# TECHNICAL BULLETIN

NO 407-01-31

**SUBJECT:** IMPROVED TAIL ROTOR GEARBOX INPUT SEAL P/N 427-342-412-101, INTRODUCTION OF.

**HELICOPTERS AFFECTED:** 407, Serial Number 53000 through 53391

Figure 1. Work aid No. 1

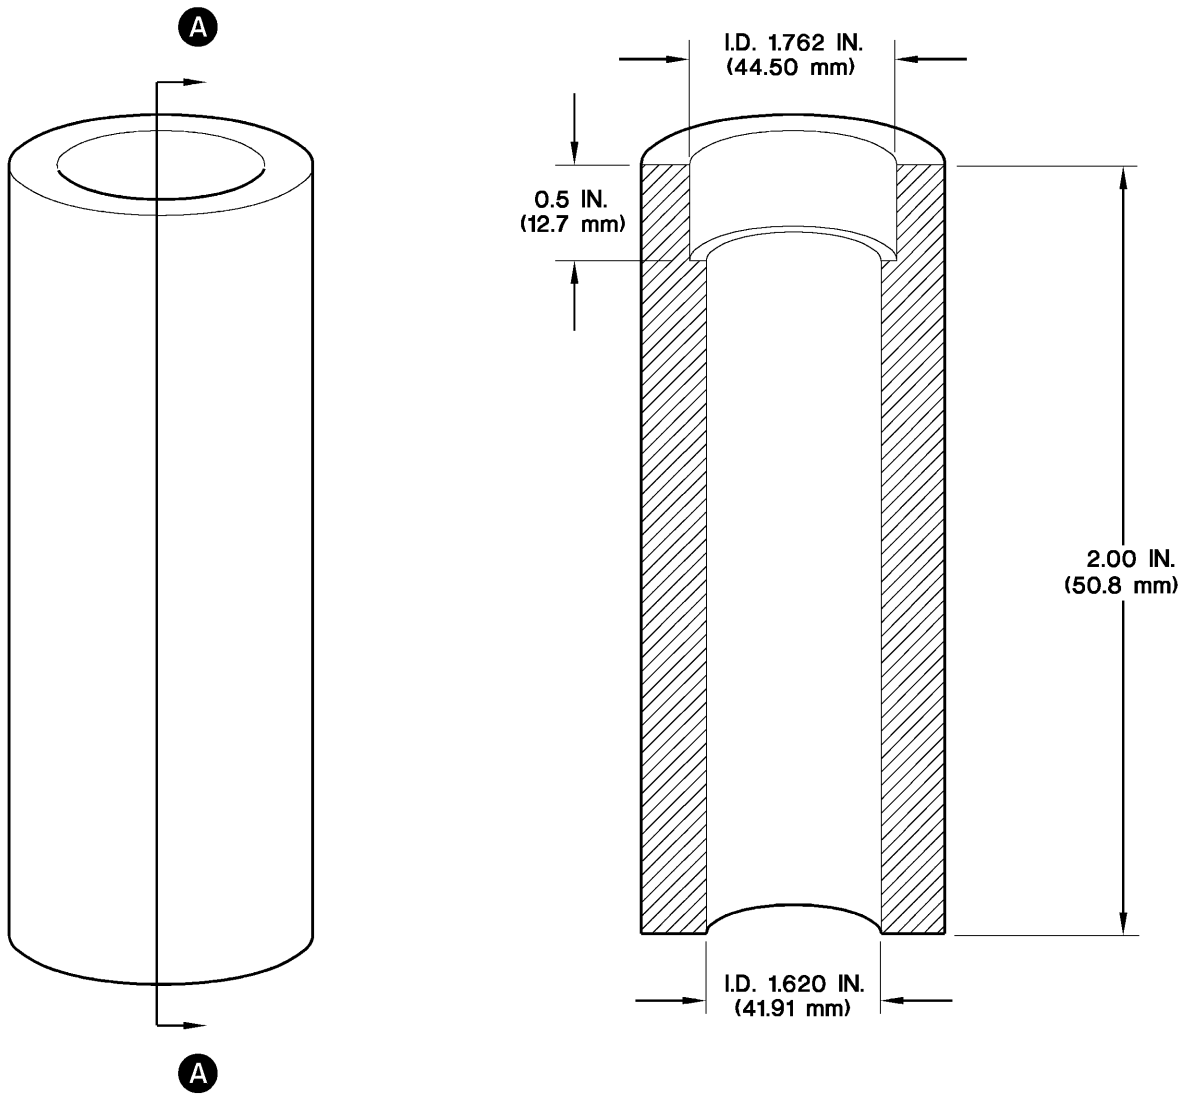
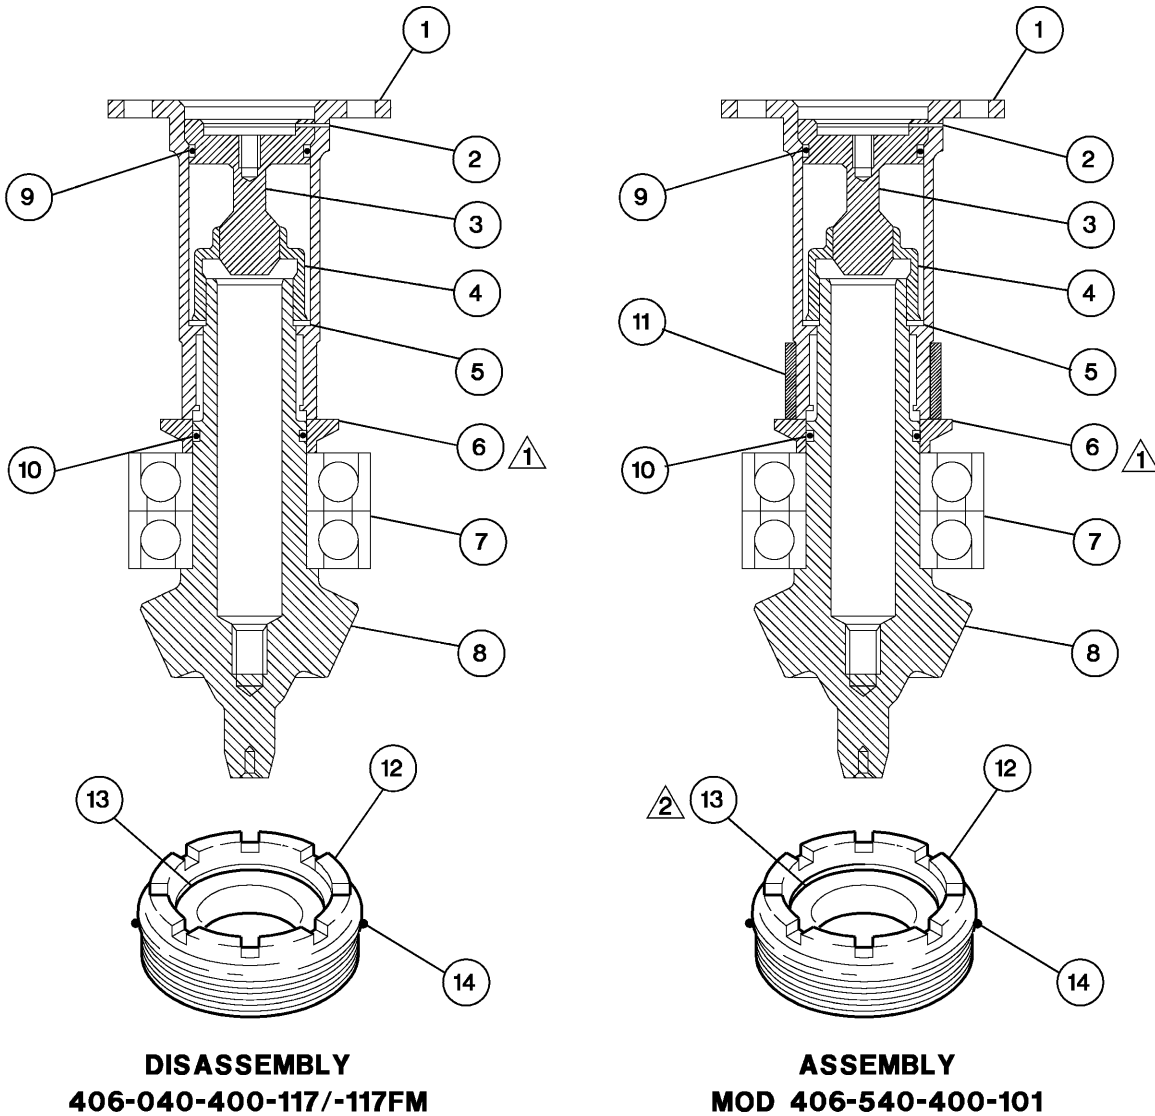
10. Use an arbor press and work aid (#1, Figure 1) to install the wear sleeve (11, Figure 4) on adapter (1). Press the wear sleeve (11) until it touches the step in adapter (1).
11. Remove any excess adhesive from adapter (1).
12. Clean the nut (12) with solvent (C-304).

**WORKAID  
(ITEM # 1)**  
MATERIAL : ALUMINIUM  
O.D. : 2.000 INCH (50.8 mm)  
I.D. : 1.620 INCH (41.91 mm)

**Figure 2. Tail Rotor Gearbox, Disassembly/Assembly**

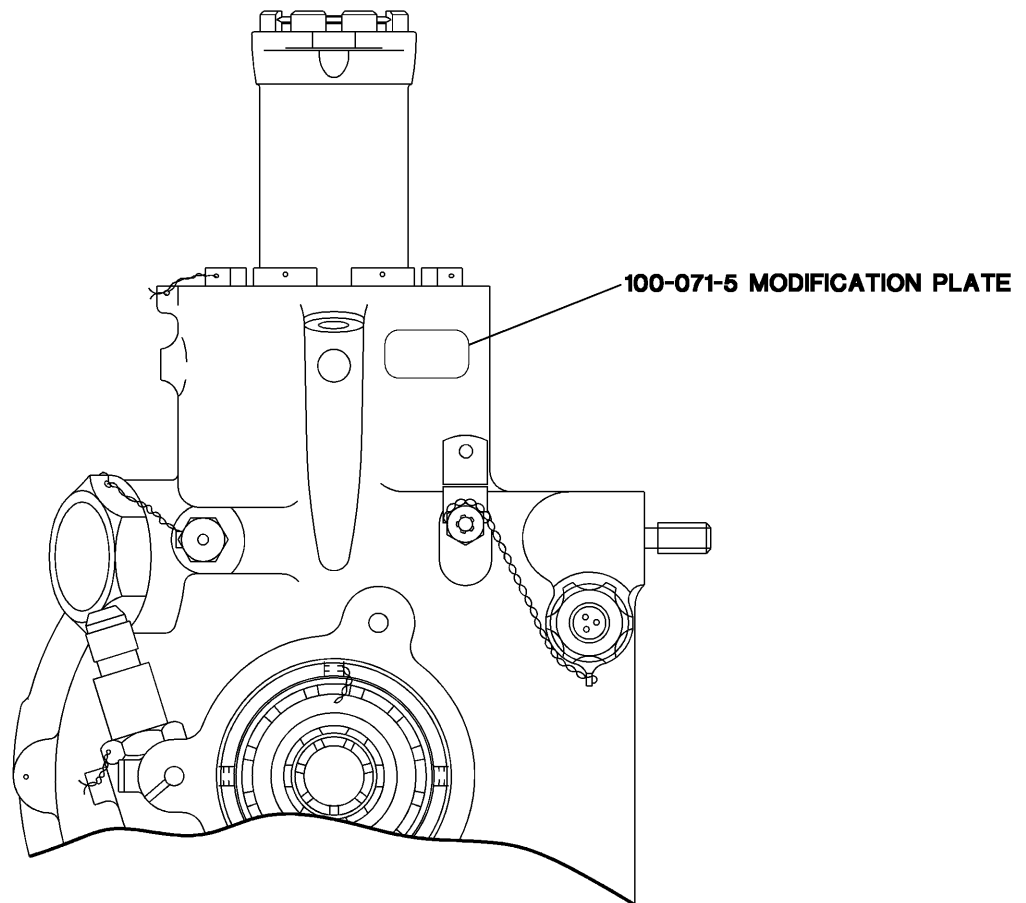
This bulletin is issued to introduce a new tail rotor gearbox input seal and wear sleeve. The new seal is a double lip design, which has performed well in test and during field evaluation. It is anticipated that this seal will improve reliability and life over the seal currently used.

4. Remove the tail rotor gearbox adapter (1, Figure 2); the nut (12), and the carbon seal (13) (Refer to BHT-407-CR&O Manual, Figures 65-5 and 65-6 for accomplishment instructions).
5. Discard the packing (9), and (14), and the carbon seal (13). Keep the seal mating ring (6) inside the gearbox.
6. Clean adapter (1) and wear sleeve (11) with solvent (C-304).
7. Apply a small bead of sealant (C-308) on the wear sleeve journal surface and on the adapter (1).
8. Apply heat to the sleeve (11).
9. Use an arbor press and a pressing plate, to install the wear sleeve (11, Figure 2) flush to 0.010 inch (0.254 mm) from the end of adapter (1).
10. Remove any excess adhesive from adapter (1).

13. Use tool 427-240-155-101 to press seal (13) into nut (12).
14. Apply a small bead of sealant (C-308) to the mating line of seal (13) and the nut (12).
15. Make sure that the seal mating ring (6) is in position inside the gearbox.
16. Install the nut (12) with the new packing (14) (Refer to BHT-407-CR&O Manual, Figure 65-12 for accomplishment instructions).
17. Remove the seal shipping mandrel.
18. Lubricate the seal lips and adapter with transmission oil.

19. Installed the adapter (1), packing (9), nut (4), plug (3), and spring lock (2) (Refer to BHT-407-CR&O Manual, Figure 65-6 for accomplishment instructions).
20. Install the bearing and hanger segmented shaft assembly you removed in Step 3 (Refer to Maintenance Manual BHT-407-MM-7, Chapter 65, for the installation instructions).
21. Use a vibrating stylus to mark the Mod plate 100-071-5 as follows:

Figure 3. Tail Rotor Gearbox – Mod Plate Installation

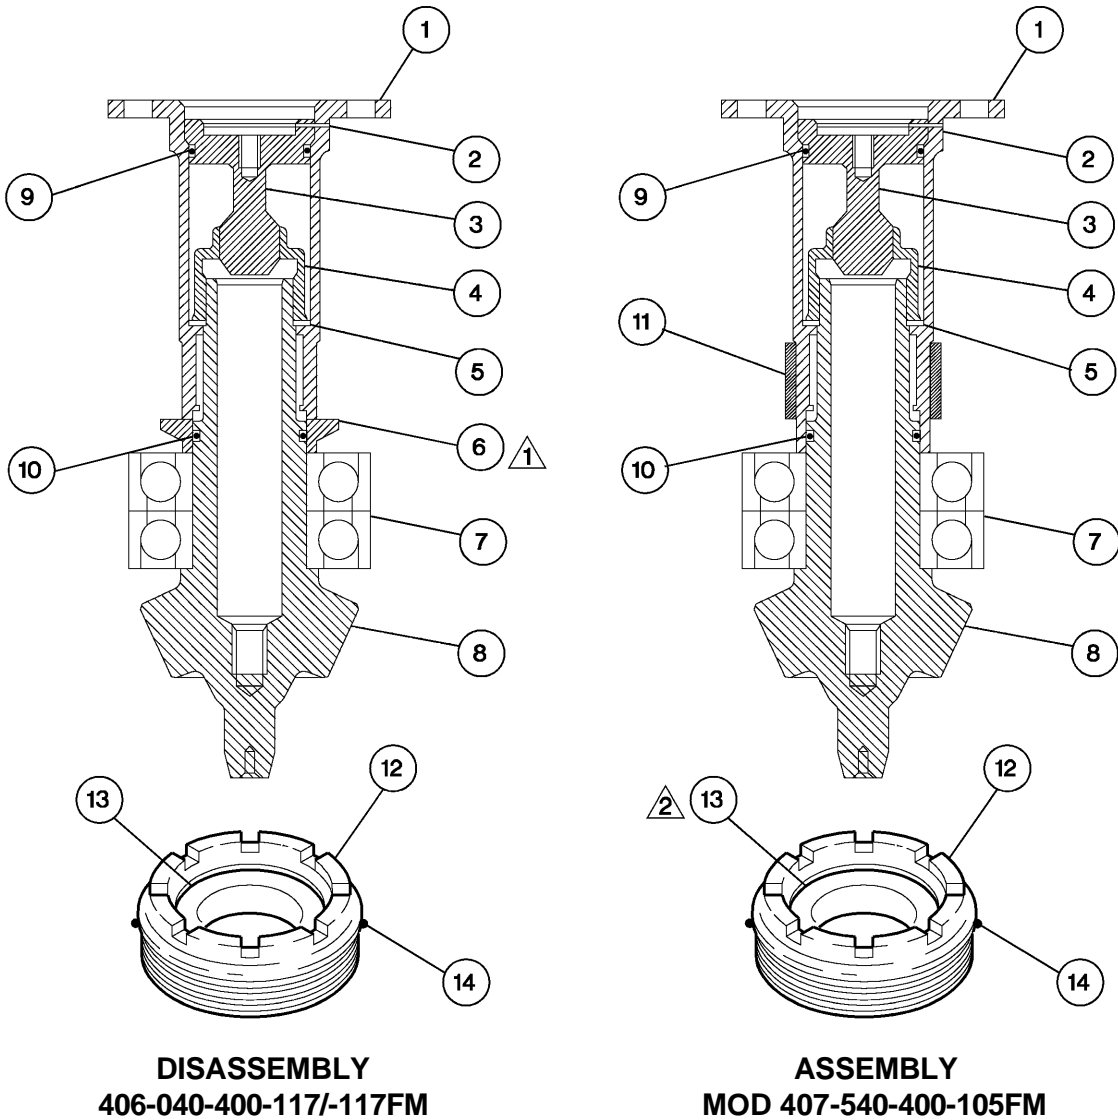
22. Form Mod plate to fit a 3.75 to 4.00 inches diameter for installation.
23. Apply adhesive (C-317) to the Mod plate 100-071-5 and install on the tail rotor gearbox as shown on Figure 3.
